SUBJECT: Petition PB-16-94 SUP. eda engineers-surveyors-planners, inc., agent for

Joyce and Jennifer, LLC, owner. Special use permit with development plan review to allow for the construction of a restaurant with a drive-through. Zoned: BUS (General business district). Located at 3208 SW Archer Road.

Bojangles
PB-16-00094
Special Use Permit W/Development Plan

Response to Review Comments

C0.00

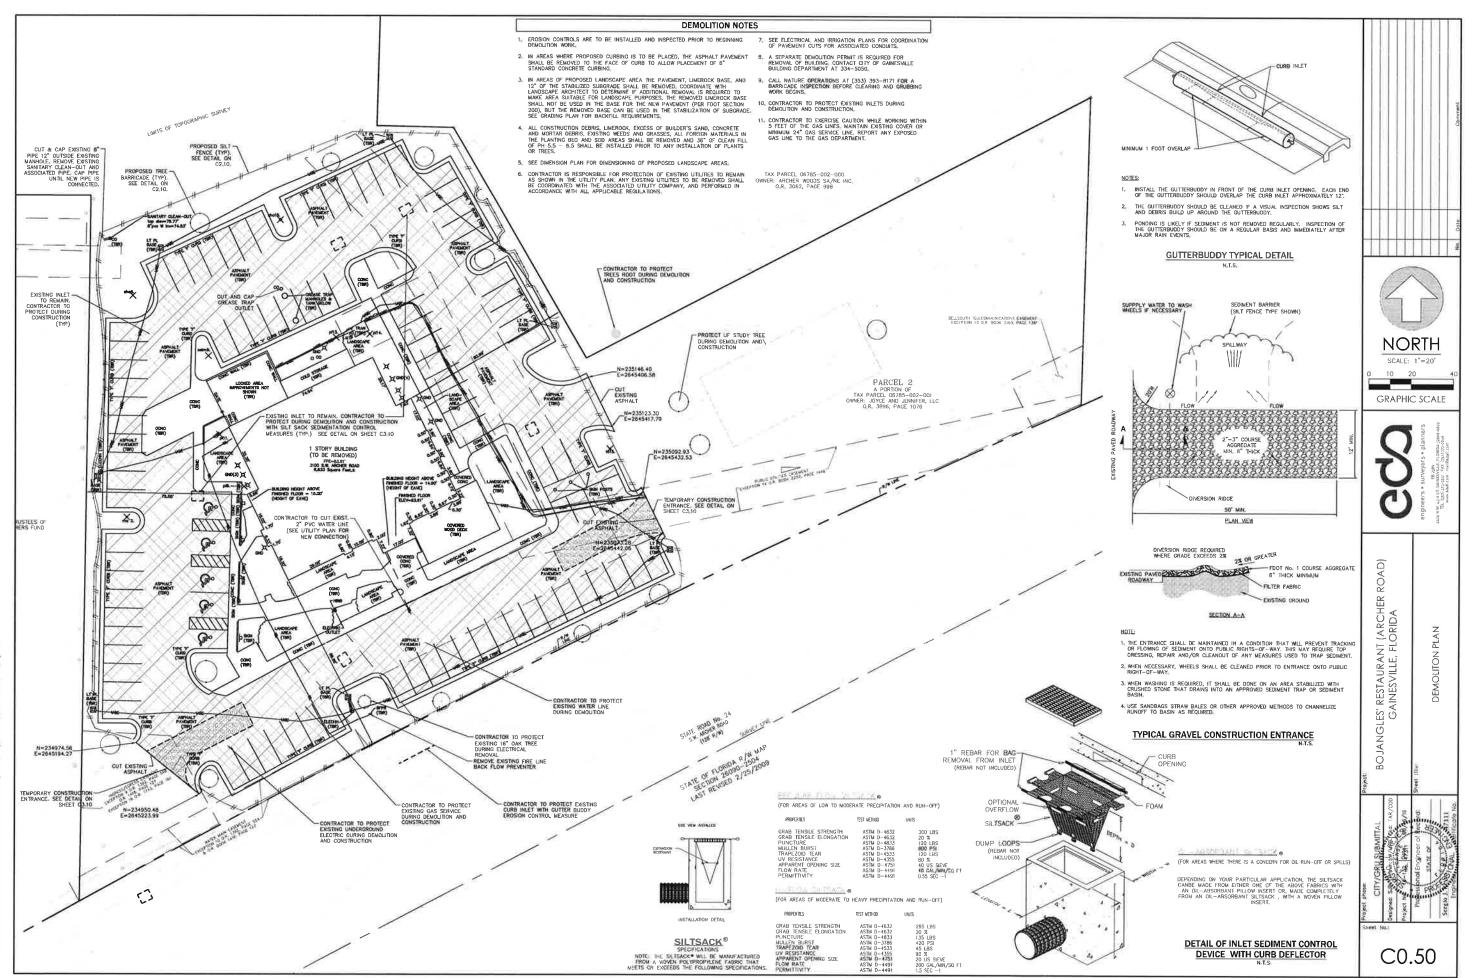
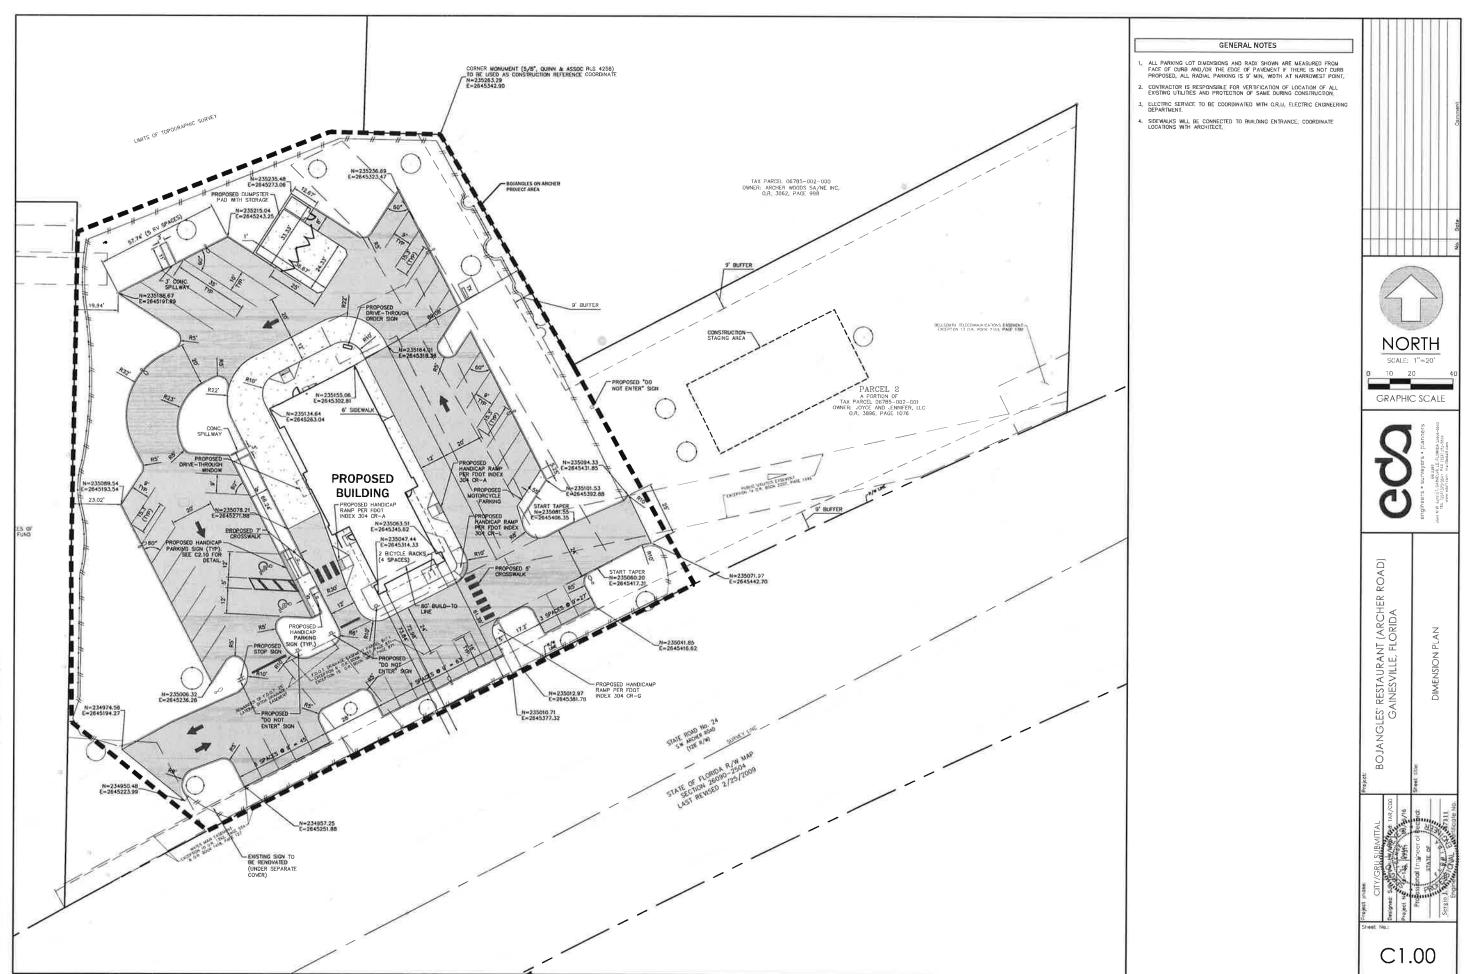
3. Please revise the trip generation numbers for the previous restaurant land use, specifically the AM and PM trips. The City of Gainesville uses AM and PM peak hour trips based on adjacent street traffic. The trip generation calculations used the AM and PM Peak Hour of Generator numbers.

4. Please revise the trip generation numbers for the proposed restaurant land use, specifically the AM and PM trips. The City of Gainesville uses AM and PM peak hour trips based on

adjacent street traffic. The trip generation calculations used the AM and PM Peak Hour of Generator numbers. Also, please add the decimal to the average daily total (1834.9, but it is shown as 18349 in the trip generation memorandum and on sheet C0.00.

5. Please revise the overall net trip total for the average daily trips. The total shown in Table 3 of the trip generation memorandum and on sheet C0.00 is 103, which is not correct based on the calculations (1834.9 - 996.5 = 838.4 / 25% of 838.4 = 209.6 / 838.4 - 209.6 = 628.8).

7. Please amend note #22 on sheet C0.00, as it refers to Policy 10.4.1 when it should refer to Policy 10.1.4.

1. Please add a note to the cover sheet: The development shall comply with The Florida Fire Prevention Code. [Gainesville Fire Prevention and Protection Code Section 10-5(a) & (b)]

Response: The trip generation calculation has been revised. Please refer to sheet C0.00 and the attached trip generation memo.

Response: The trip generation calculation has been revised. Please refer to sheet C0.00 and the attached trip generation memo.

Response: The trip generation calculation has been revised. Please refer to sheet C0.00 and the attached trip generation memo.

Response: Note 22 on sheet C0.00 has been revised as requested.

Response: The note has been added as requested. Please refer to sheet C0.00, note #20.

rver3\engprajects\bajangles restaurant - 3100 sw arther road\Plans\current dwg\816132j1 dwg. C1 00 DIM, 8/15/201E 6 08

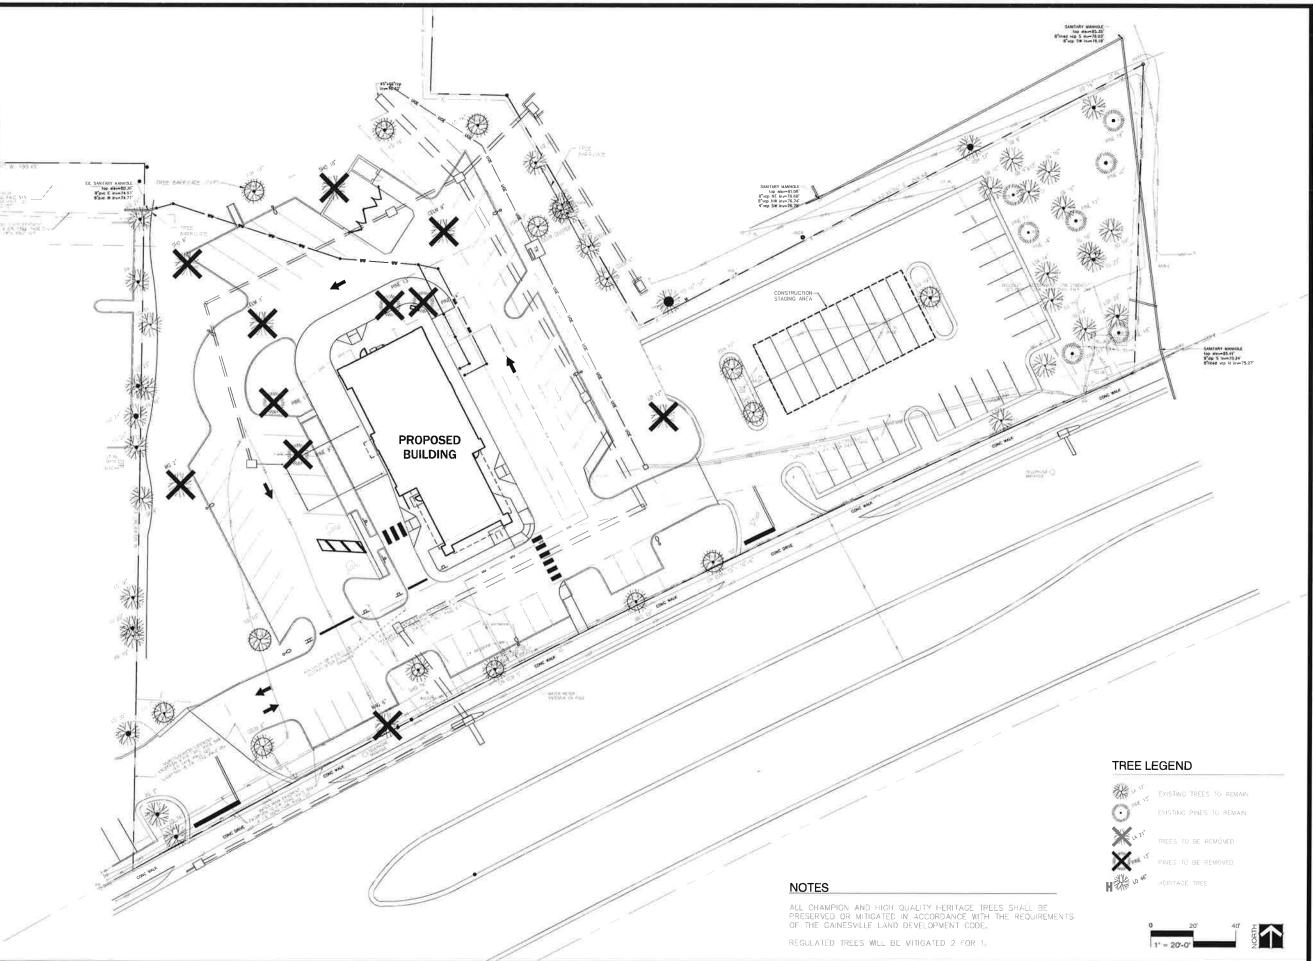
5. The proposed photometric plan does not appear to meet the requirements of Sec 30-344(4) with respect to lighting levels.

7. The wall sconces shown on the elevations are listed as metal halide fixtures whereas the photometric sheets are listed as LED. Please clarify.

8. Please provide both the uniformity ratio and maximum uniformity ratio. 8. Please indicate whether the proposed pole and wall fixtures are full cut-off.

Response: See revised photometric plans,

Response: LED wall sconces are a Bojangles standard.

Response: AVG/Min and Max/Min uniformity ratio are under Lot Summary / Fixtures have 0 uplight with flat lens.

Response: "Do Not Enter" signs have been added as requested. See sheet C1.00.

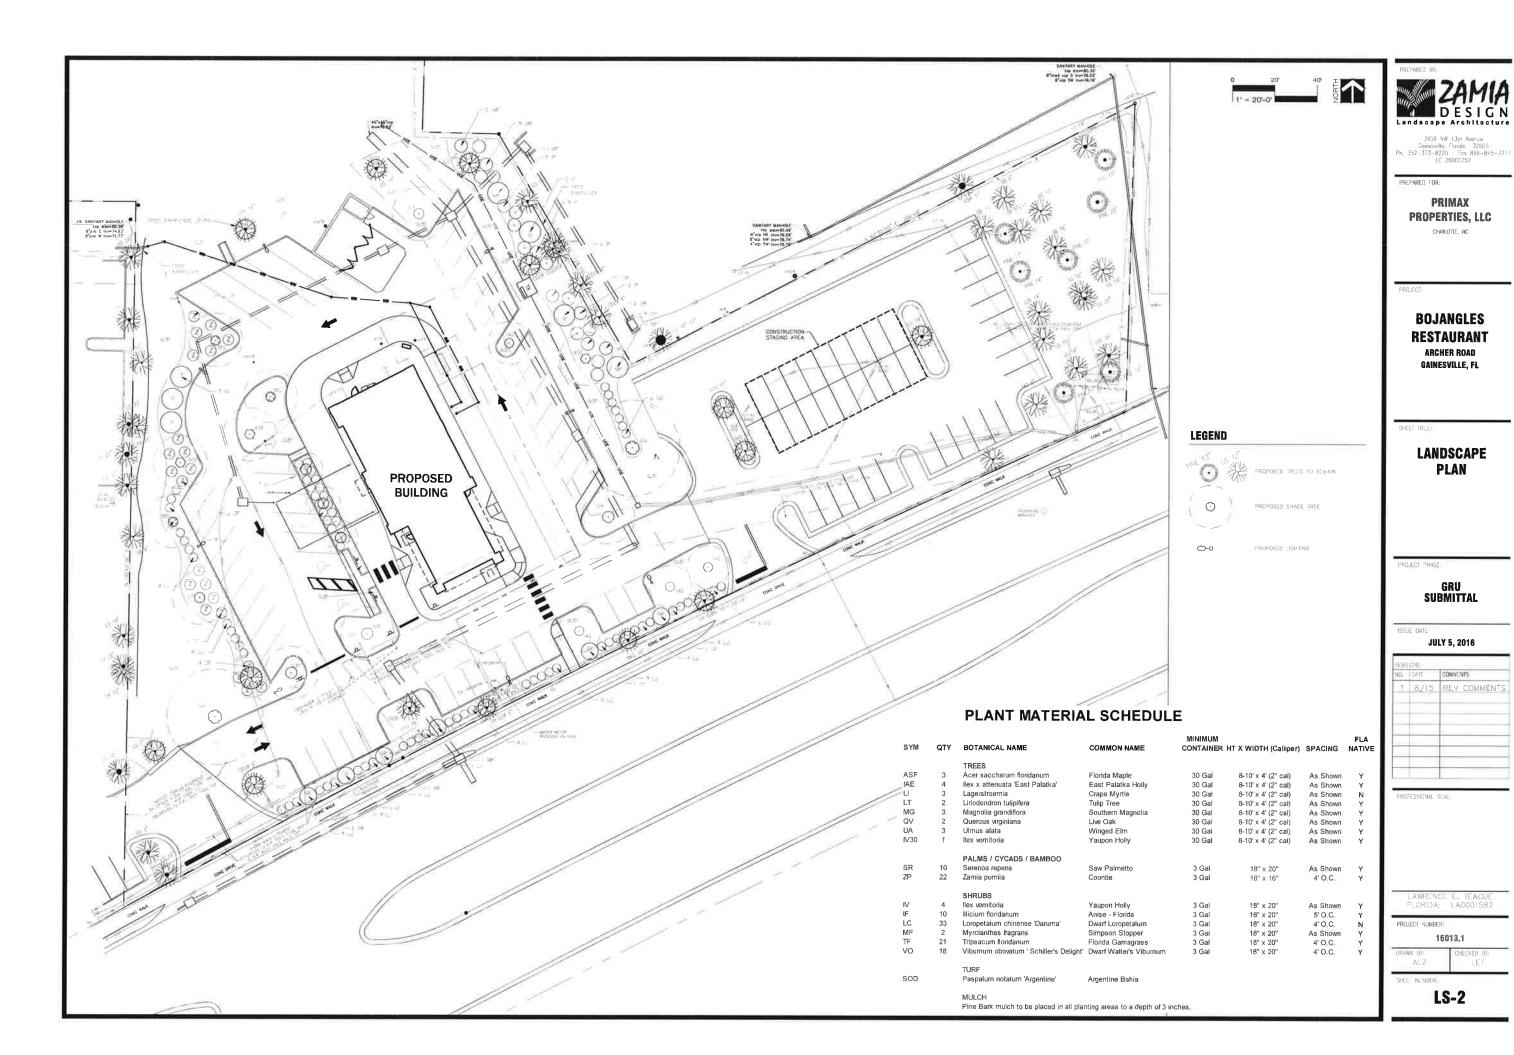
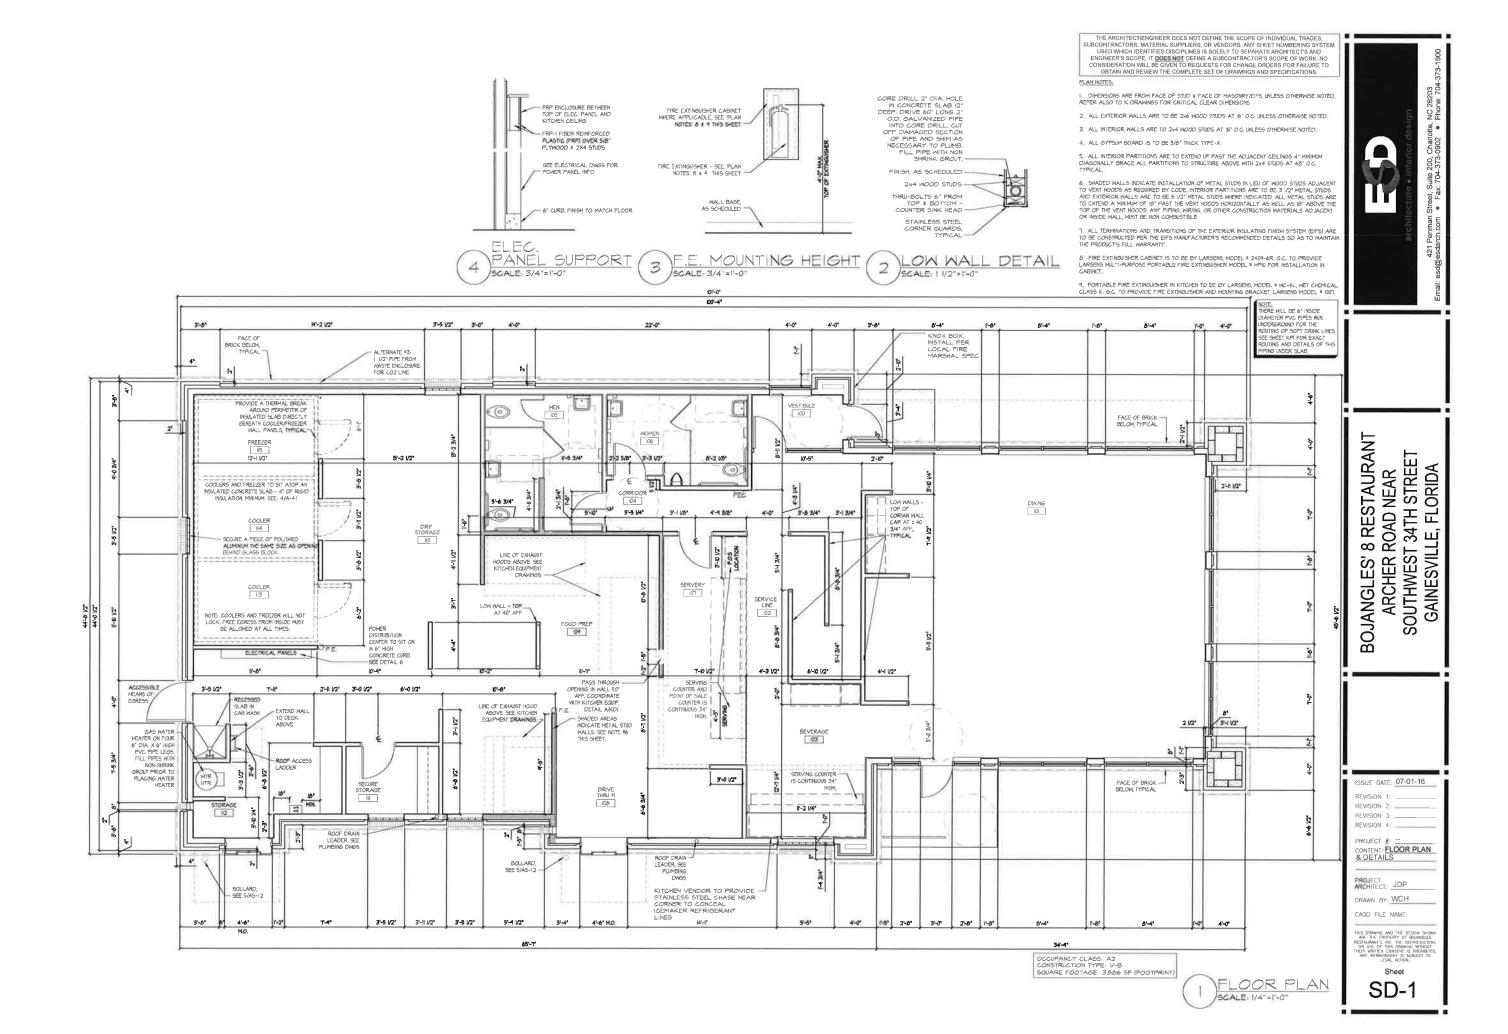
9.Please provide tree barriers for the trees to be preserved for the development indicating the entire drip line for heritage trees and 2/3 of the drip line for regulated trees on the landscape sheet.

10.Please add these notes to sheet LS-3; call the urban forestry inspector at 352-393-8188 for a tree barricade inspection before clearing and grubbing work begins. Call the urban forestry inspector at 352-393-8188 for a pre-site visit before purchasing any plant materials.

Response: Barricades are now provided and shown on Landscape Plans LS-1 and LS-2.

Response: Notes have been added to Landscape Plan sheet LS-3.
